May 23, 2011

**Reference: Response to Administrative Review of Application for New MSW Permit
Rancho Viejo Waste Management, LLC Type I Landfill - Permit No. 2374
Laredo, Webb County, Texas**

APPLICATION FOR PERMIT
TYPE I MUNICIPAL SOLID WASTE FACILITY
MSW PERMIT NO. 2374
PESCADITO ENVIRONMENTAL
RESOURCE CENTER
RANCHO VIEJO WASTE MANAGEMENT, LLC
SOLID WASTE DISPOSAL FACILITY
LAREDO, WEBB COUNTY, TEXAS

GENERAL LOCATION MAP			
PESCADITO ENVIRONMENTAL RESOURCE CENTER MSW PERMIT NO. XXXX WEBB COUNTY, TEXAS			
PROJECT NO.	170401	DWG FILE	170401-MSW-I-1
DRAWN BY.	CL	DATE	02/14/11
505 EAST HUNTLAND DRIVE SUITE 250 AUSTIN, TEXAS 78752 (512) 329-6080			FIGURE 1 PART I PAGE XX

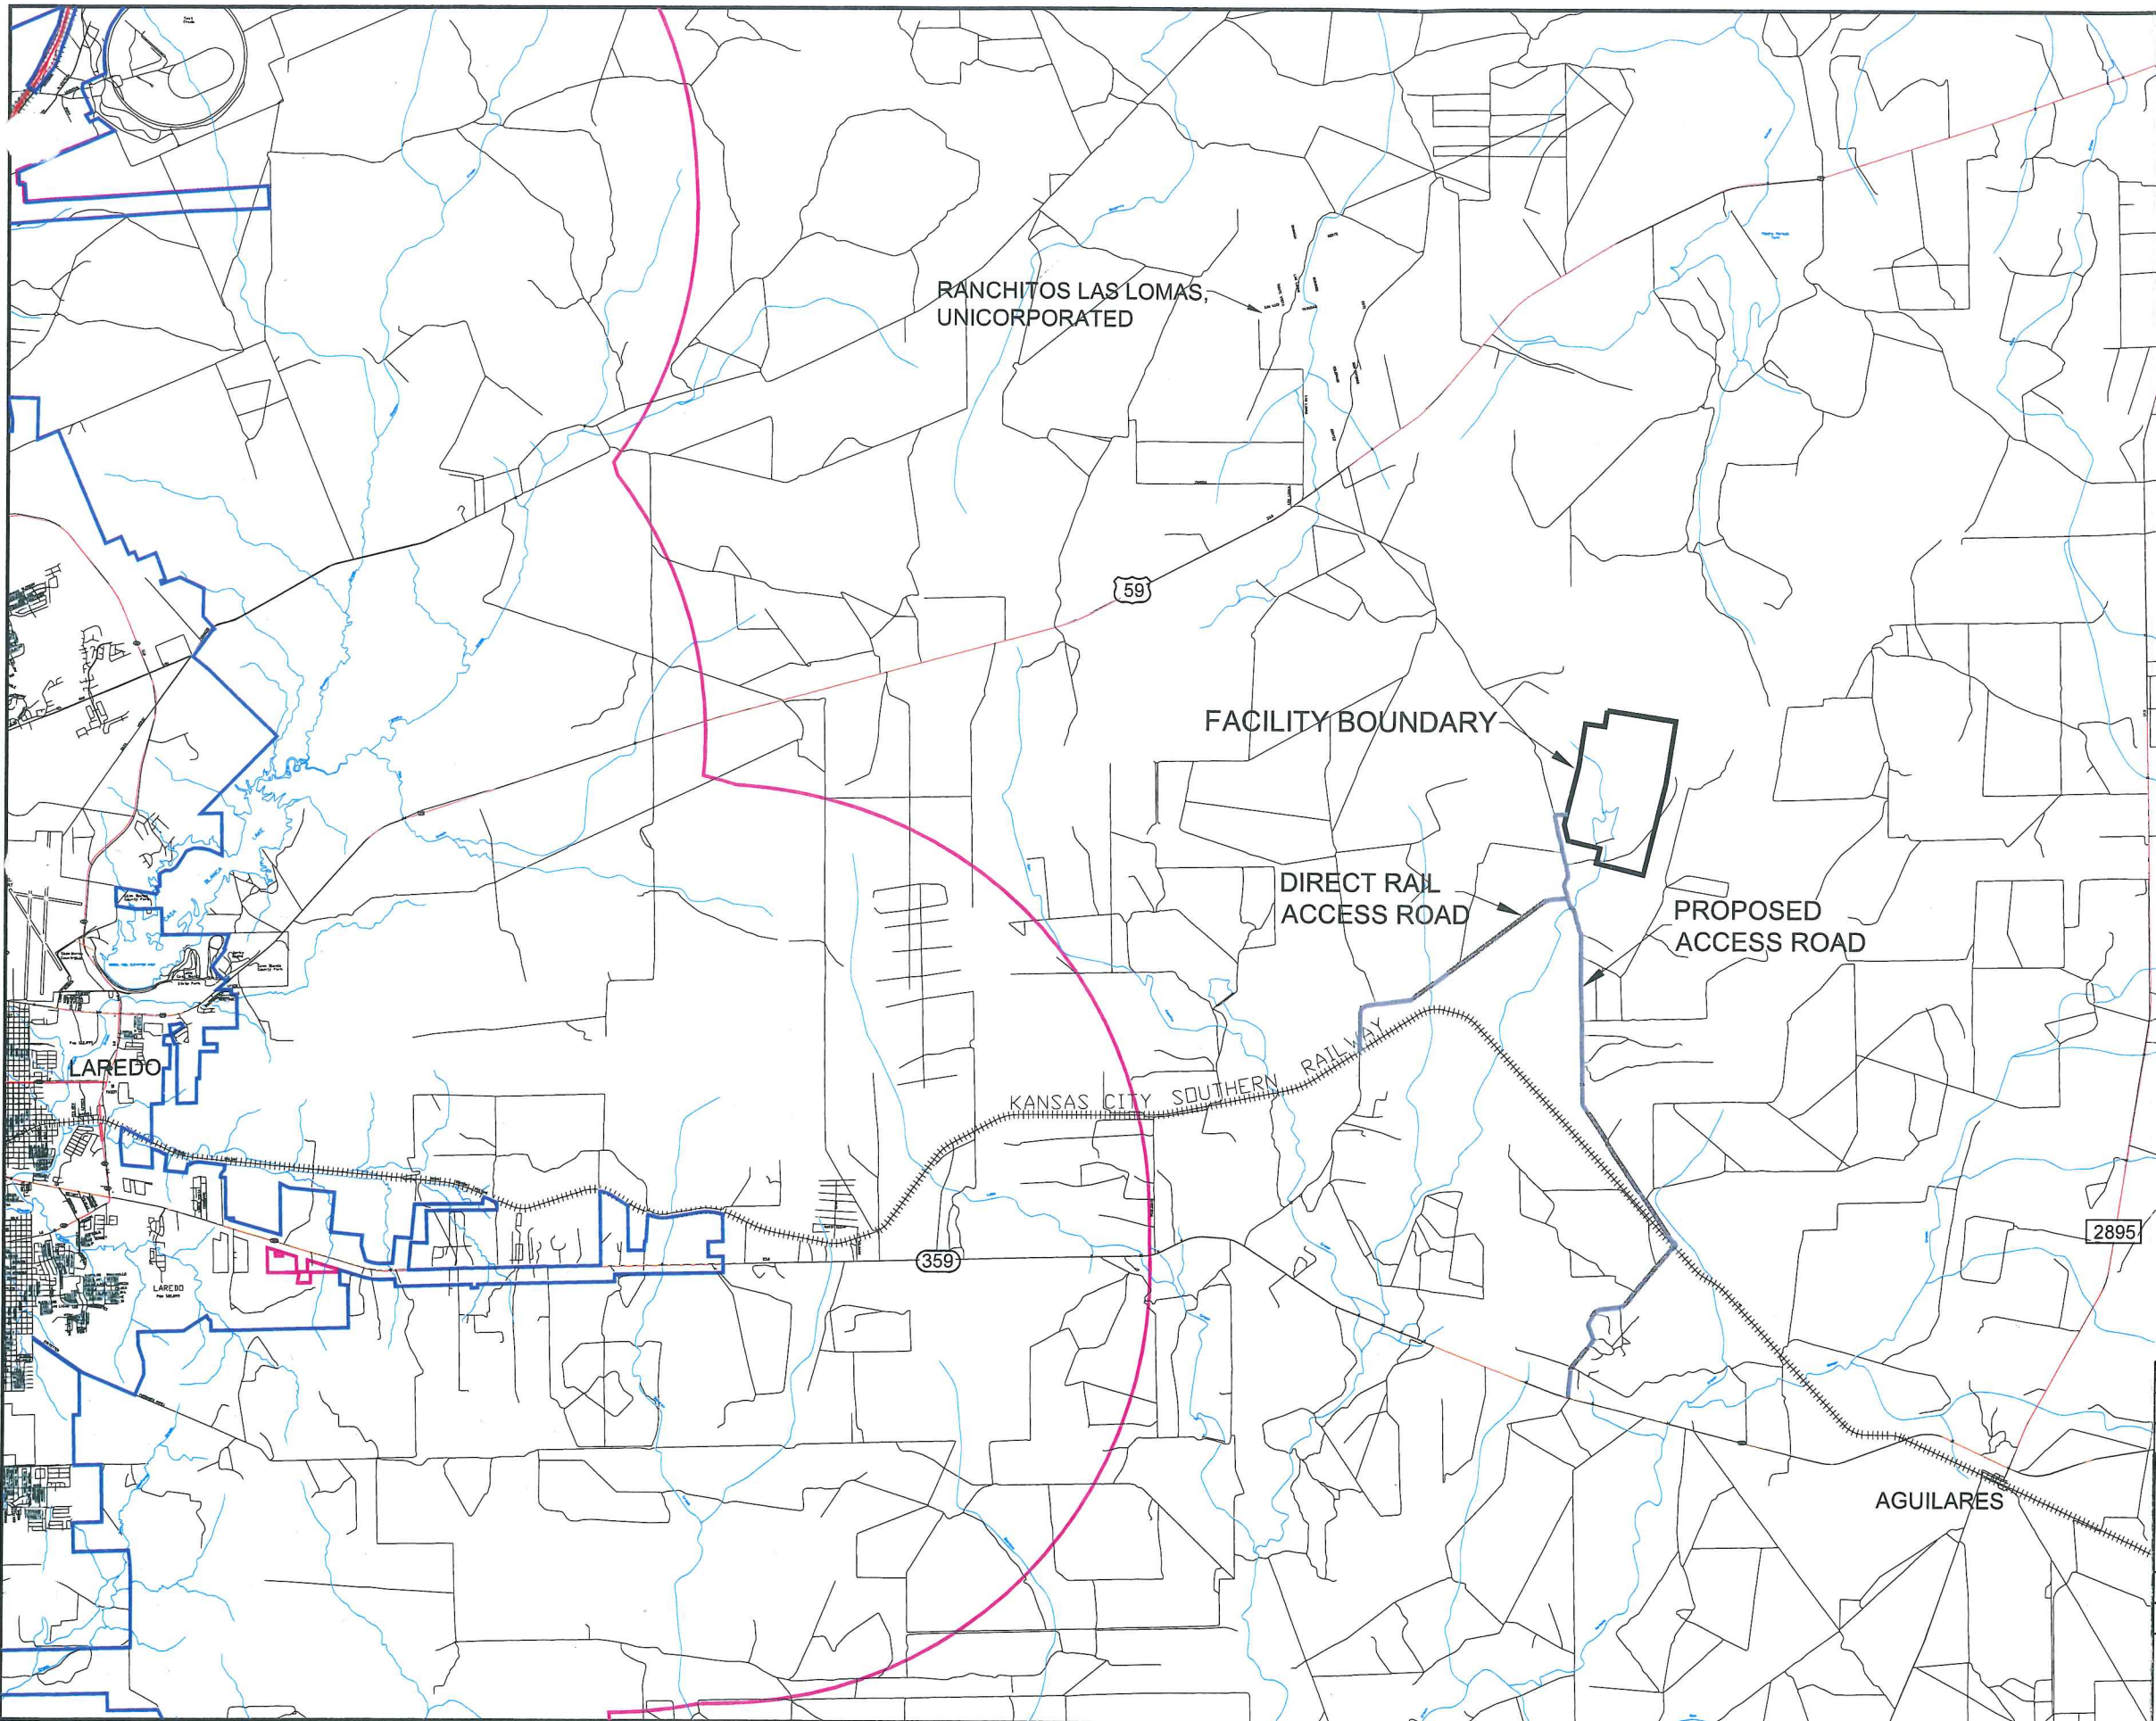
1. We have revised and are resubmitting Page 2 of the Part I Application form to indicate the application is for both a Type I and a Type V facility.
2. We have initiated the coordination with the Federal Aviation Authority (FAA) by means of a letter dated May 13, 2011 and a copy of the facility location map. Copies of these are enclosed, which will be Attachment F in Part II. When we receive a reply from FAA, we will supplement this response by sending copies to you. We added a reference to airport safety on page 20 of Part II, and are enclosing copies of it.
3. The proposed facility is not within the territorial limits and extraterritorial jurisdiction of any city. We have revised the General Location Map, Figure 1 of Part I to show the boundaries that exist (copies enclosed). The Webb County Judge is:

REVISIONS		
1	ADDED LAREDO CITY LIMITS AND ETJ	04/21/11 CL
